ADDENDUM
PAGE 1 OF 4

Ohio Department of Rehabilitation and Correction
Ohio Reformatory for Women Improvements Project
Utility Tunnel Repairs & Harmon Building
Sanitary Pipe Repairs (Bid Package 2)
Project No. DRC-21F005-02
Project No. Fishbeck 220248

Addendum No. 01

Date: October 16, 2023

ALTERNATE 1A
BASEMENT AREA A SANITARY PIPING PLAN
SCALE: 1/8" = 1'-0"
FINISHED FLOOR ELEVATION = 1054.25

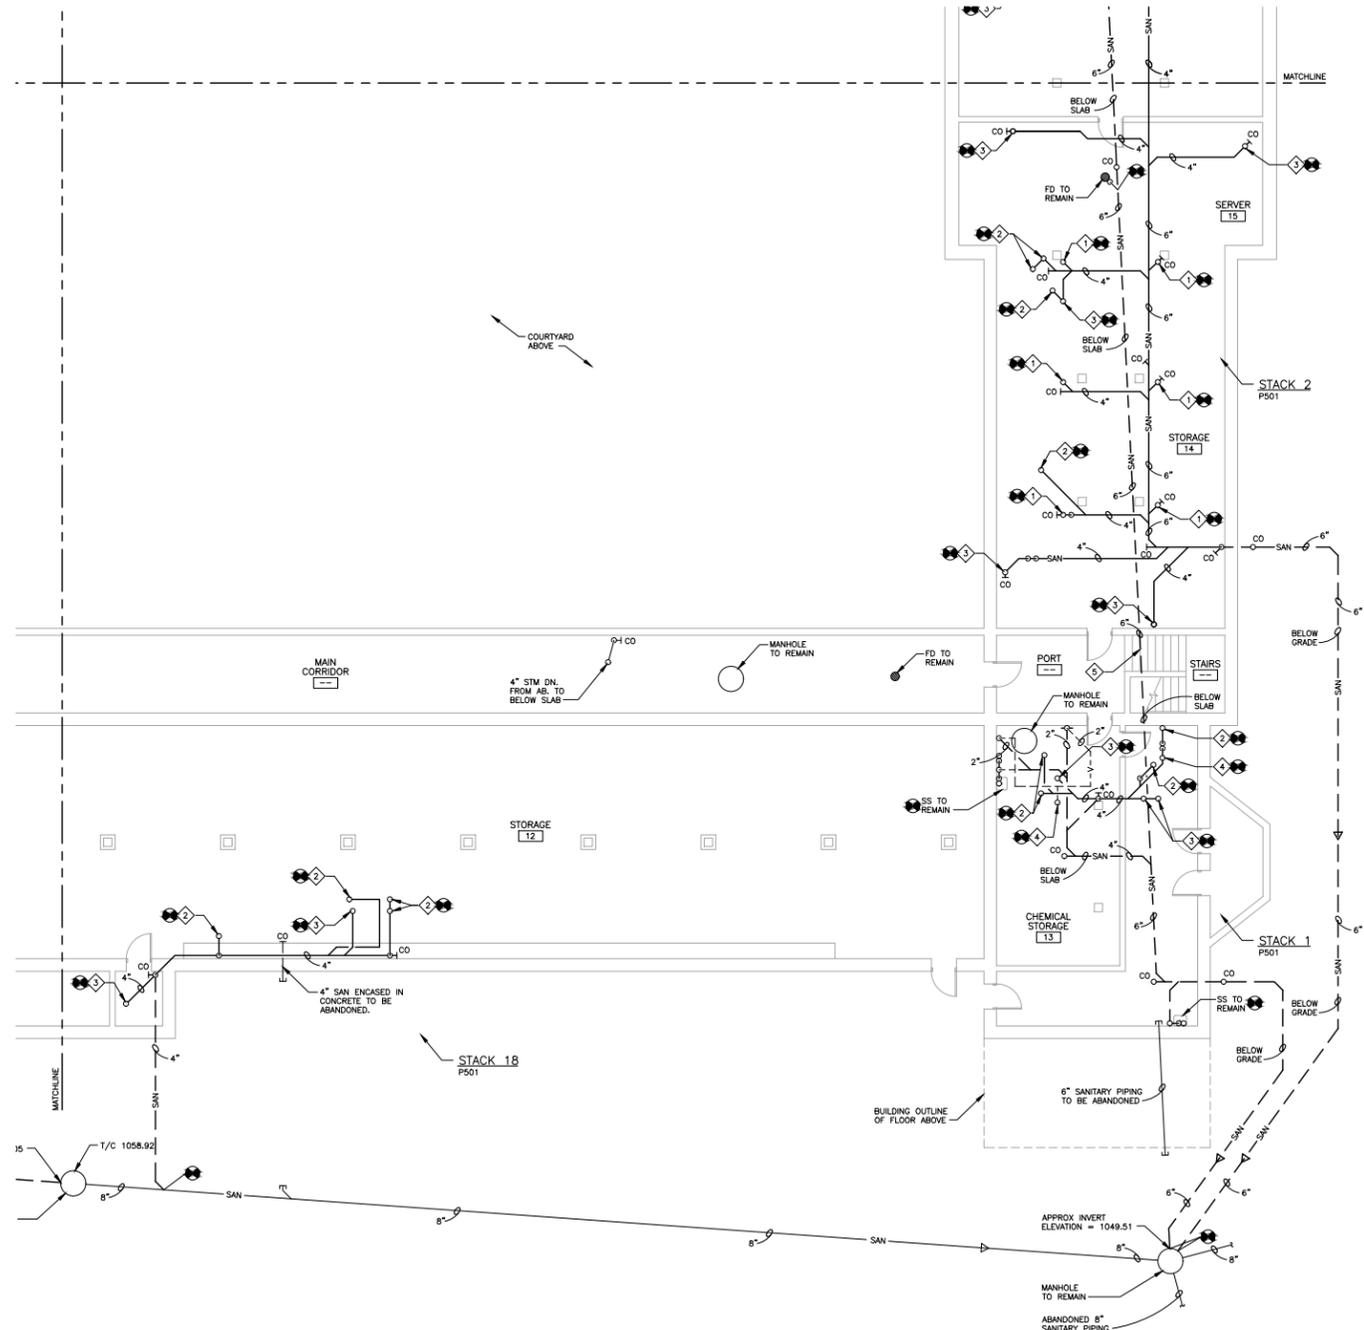
Sheet: 2.P01 – BASEMENT AREA A SANITARY PIPING PLAN - ALTERNATE 1A (reissued)

- A. Added the following general note to the drawing “Provide test cleanouts at connections to existing sanitary locations as required”.

ALTERNATE 1A
BASEMENT AREA B SANITARY PIPING PLAN
 SCALE: 1/8" = 1'-0"
 FINISHED FLOOR ELEVATION = 1054.25

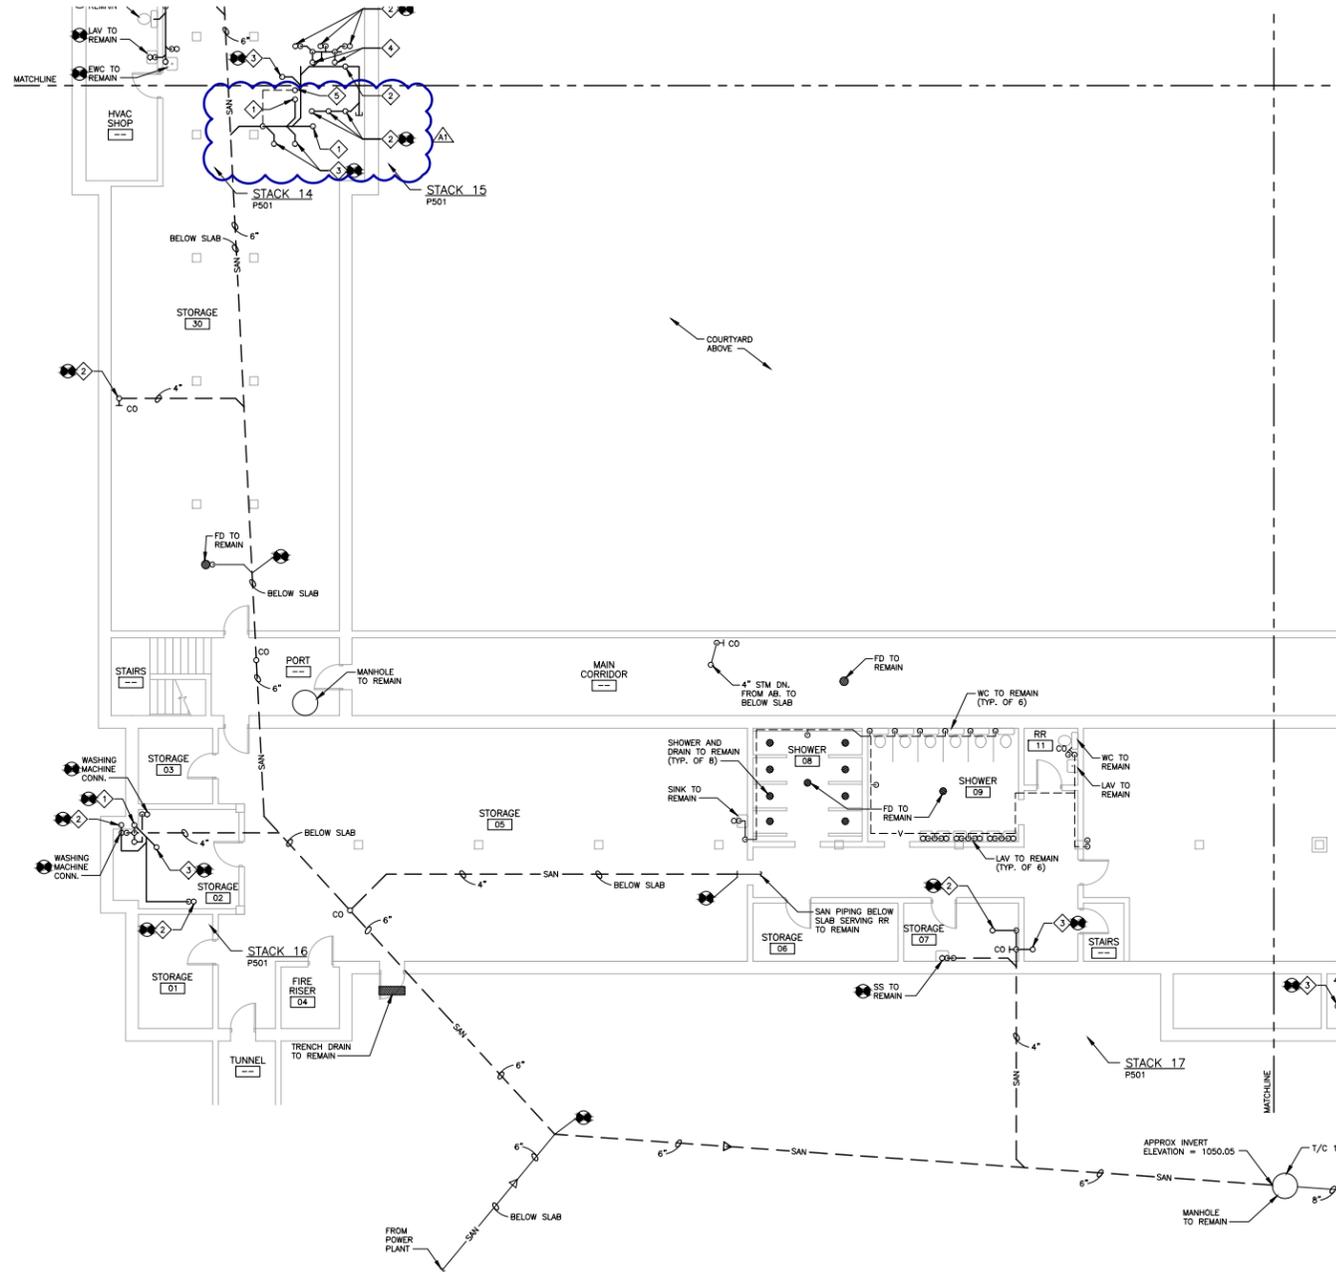
Sheet: 2.P02 – BASEMENT AREA B SANITARY PIPING PLAN - ALTERNATE 1A (reissued)

- A. Added the following general note to the drawing "Provide test cleanouts at connections to existing sanitary locations as required".

ALTERNATE 1B
BASEMENT AREA C SANITARY PIPING PLAN
 SCALE: 1/8" = 1'-0"
 FINISHED FLOOR ELEVATION = 1054.25

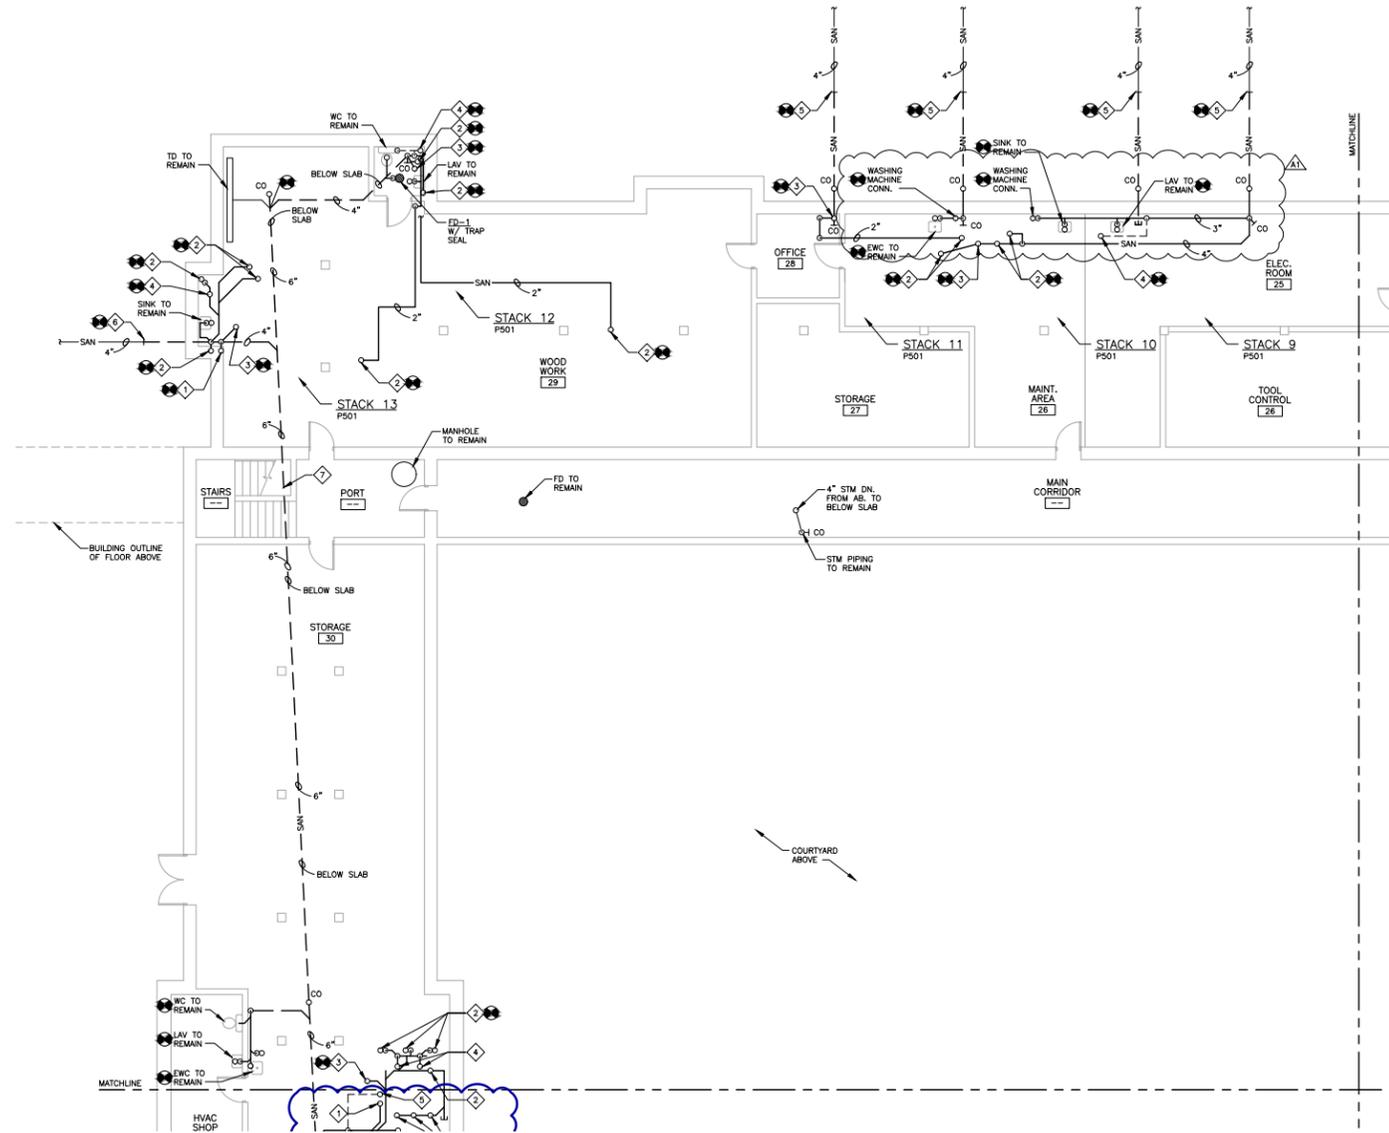
Sheet: 2.P03 – BASEMENT AREA C SANITARY PIPING PLAN - ALTERNATE 1B (reissued)

- A. Added the following general note to the drawing "Provide test cleanouts at connections to existing sanitary locations as required".
- B. Added a 3" Vent Stack to the drawing as well as coded note 5.

ALTERNATE 1B
BASEMENT AREA D SANITARY PIPING PLAN
SCALE: 1/8" = 1'-0"
FINISHED FLOOR ELEVATION = 1054.25

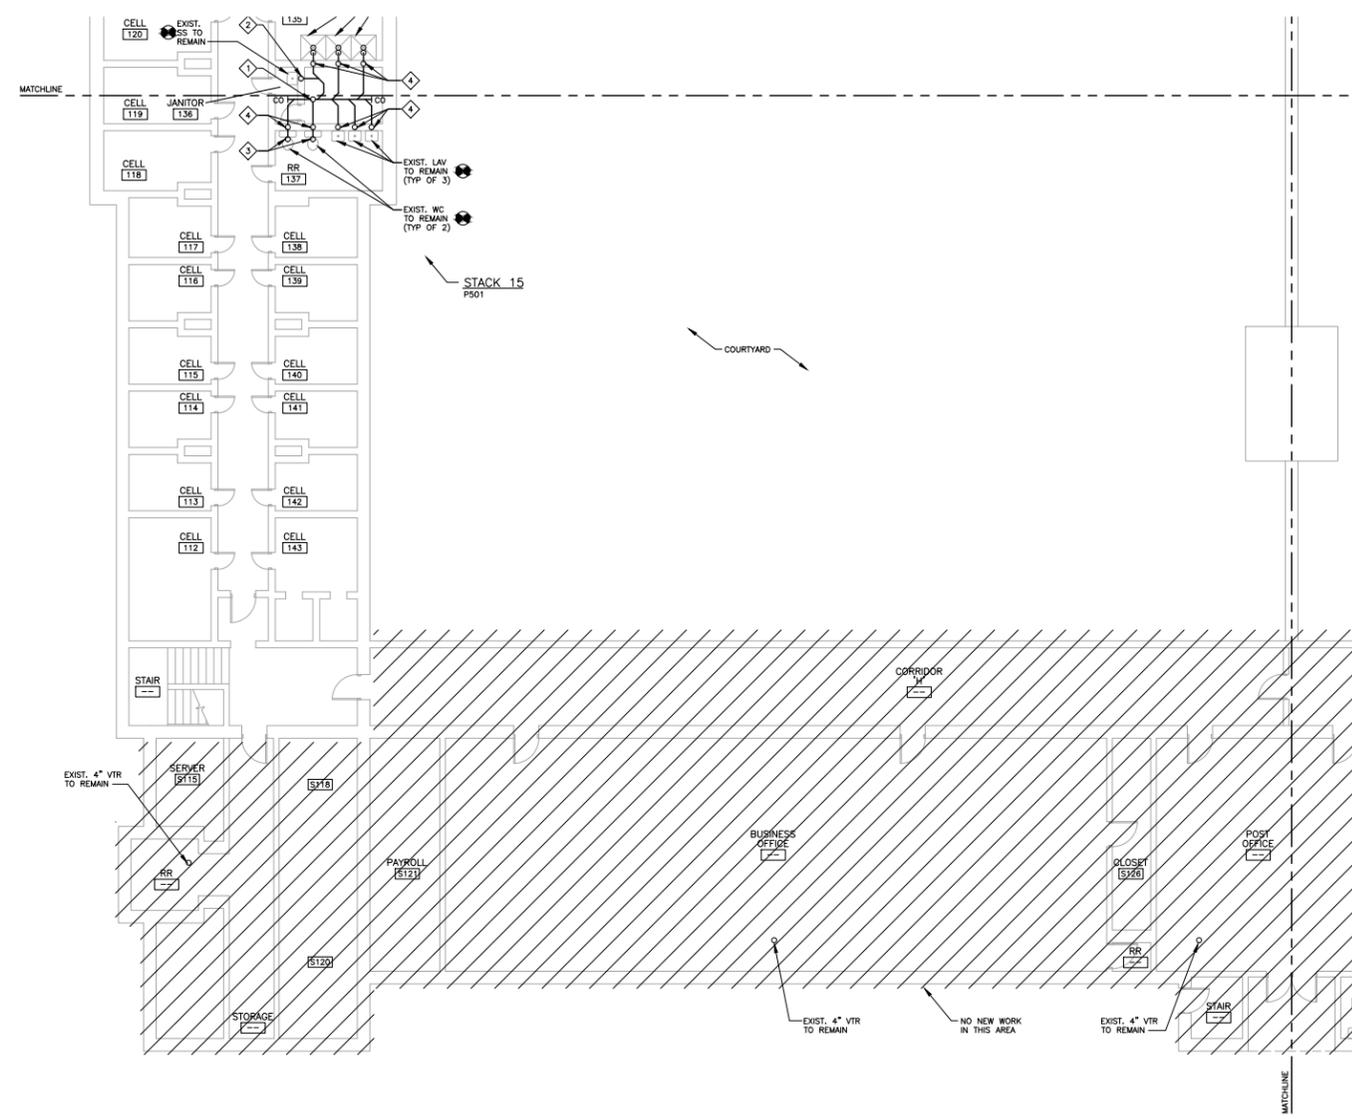
Sheet: 2.P04 – BASEMENT AREA D SANITARY PIPING PLAN - ALTERNATE 1B (reissued)

- A. Added the following general note to the drawing "Provide test cleanouts at connections to existing sanitary locations as required".
- B. Increased the sanitary trap and piping size from existing washing machine.

ALTERNATE 1B
FIRST FLOOR AREA C SANITARY PIPING PLAN
 SCALE: 1/8" = 1'-0"
 NORTH

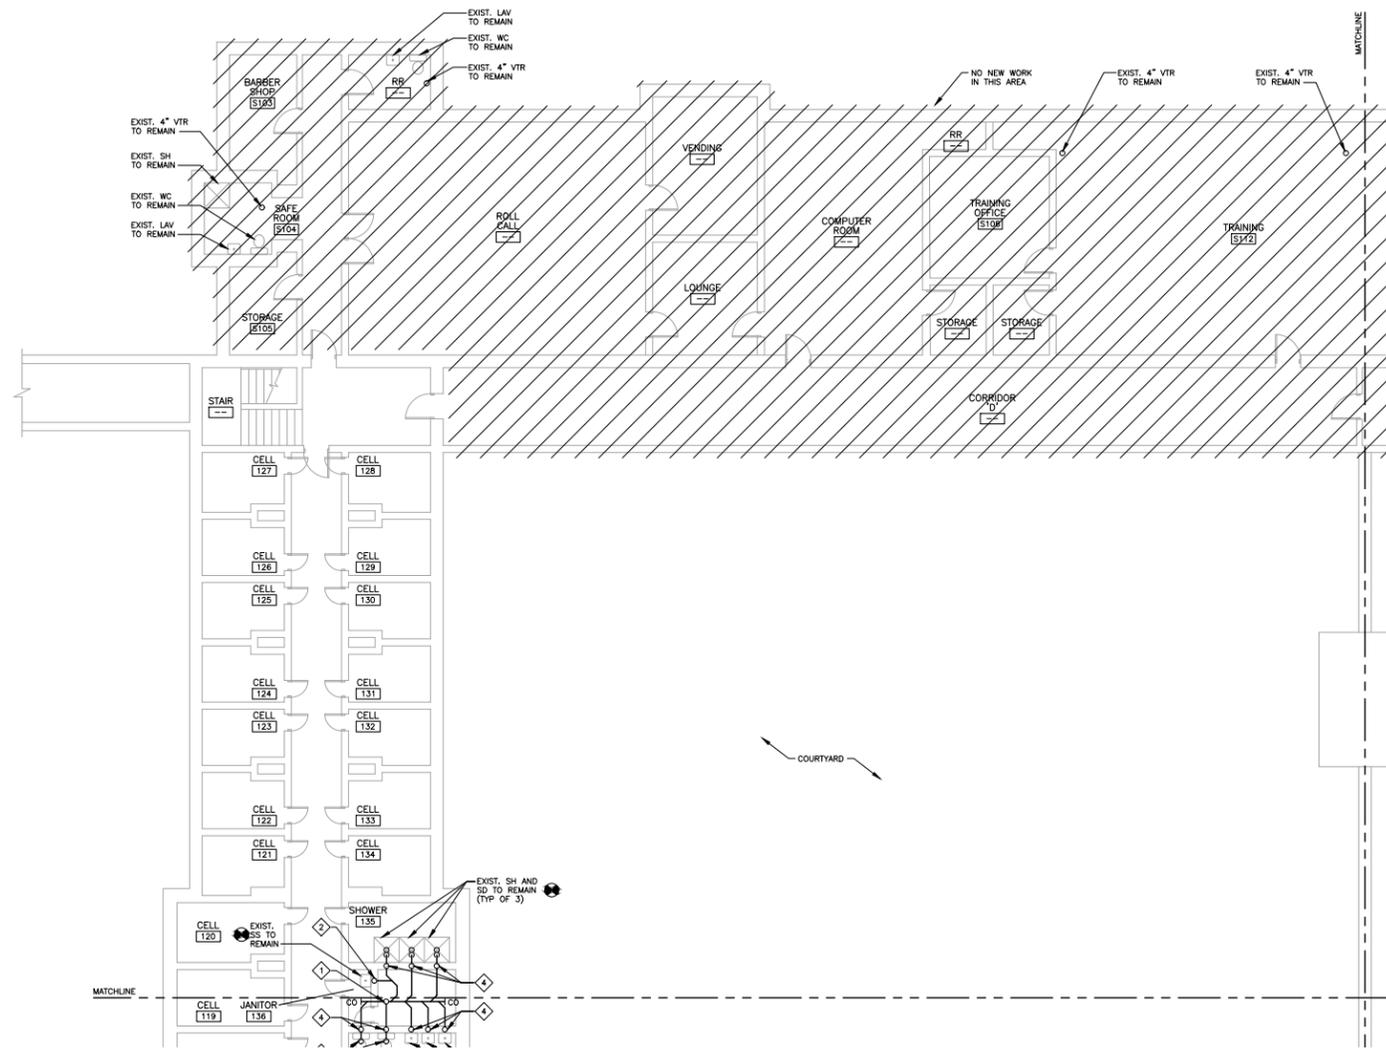
Sheet: 2.P05 – FIRST FLOOR AREA C SANITARY PIPING PLAN - ALTERNATE 1B (reissued)

- A. Added the following general note to the drawing "Provide test cleanouts at connections to existing sanitary locations as required".

ALTERNATE 1B
FIRST FLOOR AREA D SANITARY PIPING PLAN
 SCALE: 1/8" = 1'-0"
 NORTH

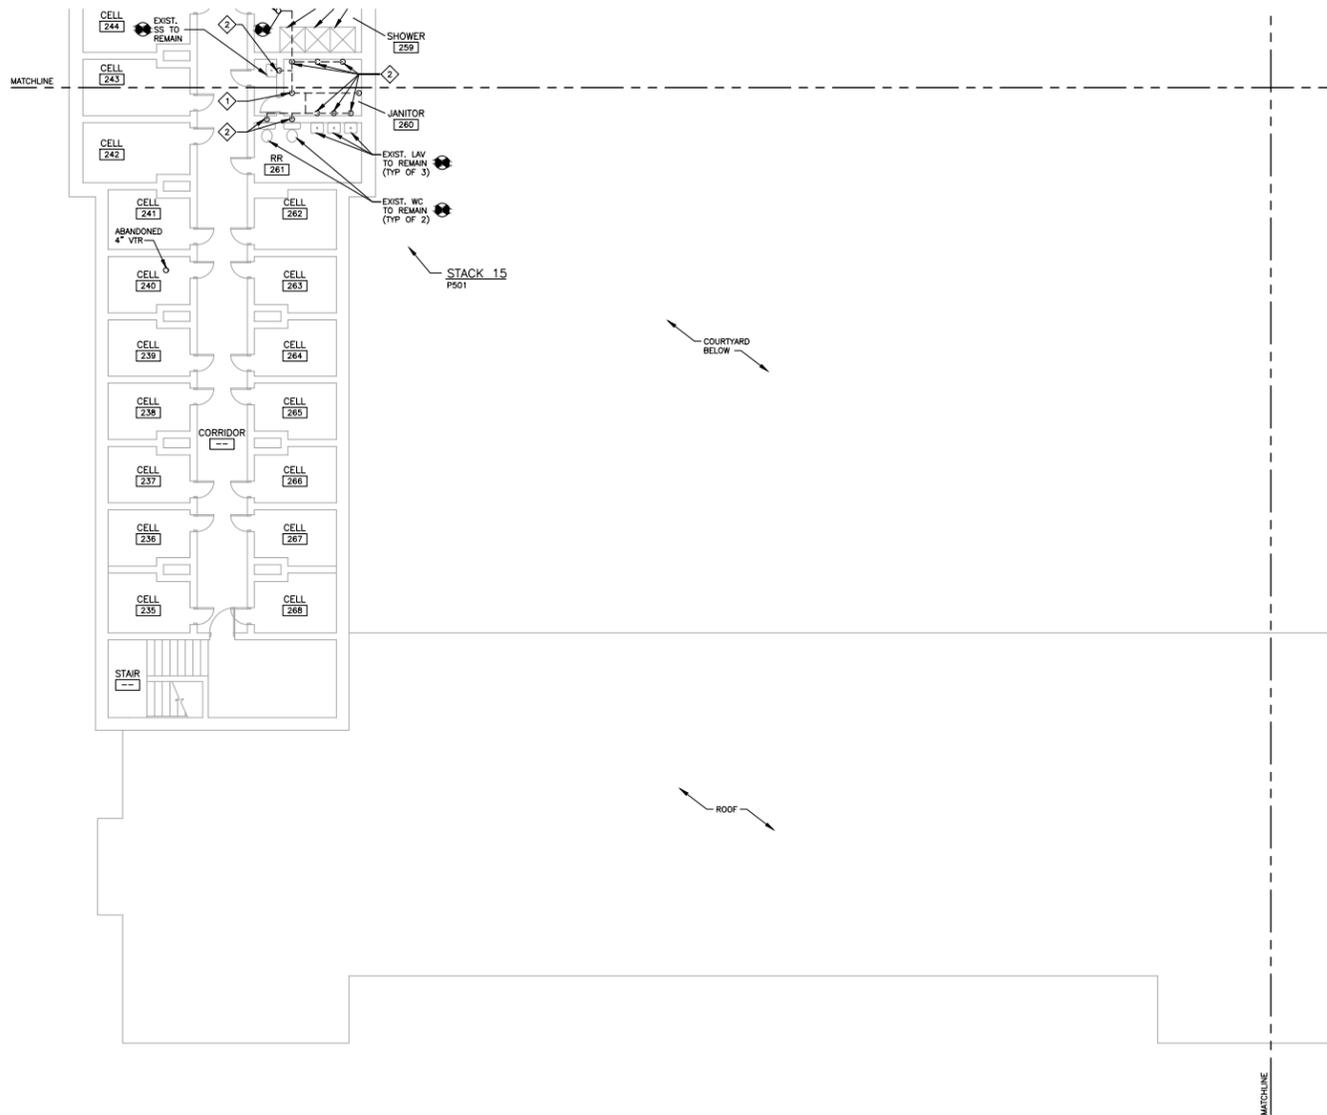
Sheet: 2.P06 – FIRST FLOOR AREA D SANITARY PIPING PLAN - ALTERNATE 1B (reissued)

- A. Added the following general note to the drawing "Provide test cleanouts at connections to existing sanitary locations as required".

ALTERNATE 1B
SECOND FLOOR AREA C SANITARY PIPING PLAN
 SCALE: 1/8" = 1'-0"
 NORTH

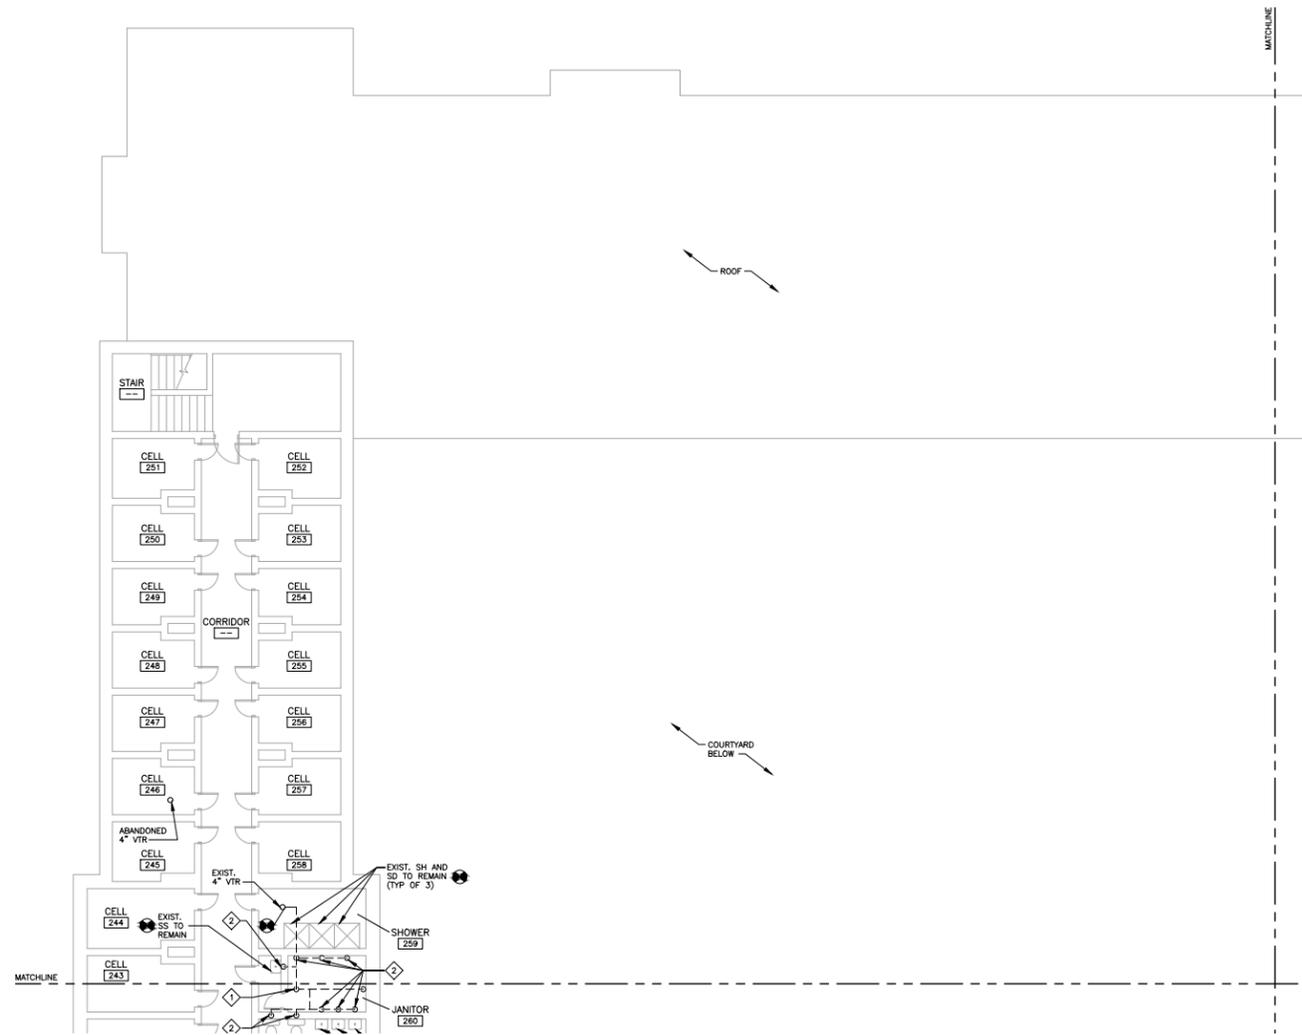
Sheet: 2.P07 – SECOND FLOOR AREA C SANITARY PIPING PLAN - ALTERNATE 1B (reissued)

- A. Added the following general note to the drawing "Provide test cleanouts at connections to existing sanitary locations as required".
